10/775,684

Office Action Summary

DETAILED ACTION

Patent Application Publication Jun. 5, 2003 Sheet 2 of 14 US 2003/0103203 A1

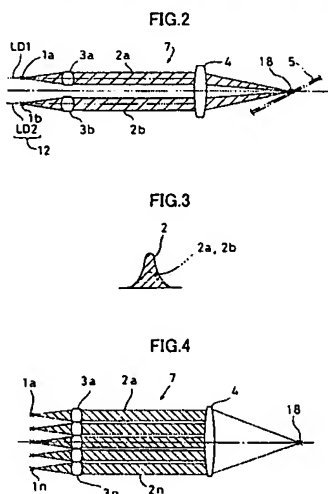
Regarding claim 3; Isozaki et al teaches said two or more laser beams (2a, 2b of figure 2) are emitted from two or more light emitting sources (LD 1 [1a of figure 2] and LD2 [1b of figure 2]).

Patent Application Publication Jun. 5, 2003 Sheet 1 of 14 US 2003/0103203 A1

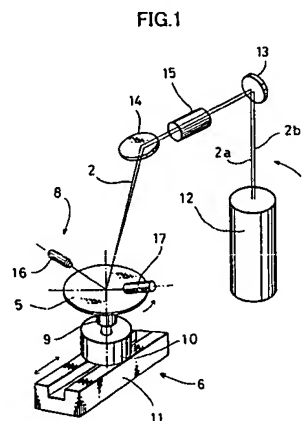
Regarding claim 1; Isozaki et al teaches a surface inspection apparatus (figure 1 and abstract) for detecting foreign matter (abstract) on a surface a substrate (5 of figure 1) by projecting and scanning laser beams (2a, 2b of figure 1) to the surface of the substrate (5 of figure 1), comprising:

a light source unit (12 of figure 1) for projecting two or more laser beams (2a, 2b of figure 1 or 2a-2n of figure 4), and a projecting optical system (7 of figure 1) for converging the laser beams (2a, 2b of figure 1 or 2a-2n of figure 4) by an image forming lens (4 of figure 4) so that the two or more laser beams (2a, 2b of figure 1 or 2a-2n of figure 4) are aligned in a row in a direction (paragraph 0086 and figure 4) of collimator lens (3a-3n of figure 4) perpendicularly crossing the scanning direction (paragraph 0074) at a projecting point (18 of figures 1-4) on the substrate (5 of figure 2). See figures 1-29.
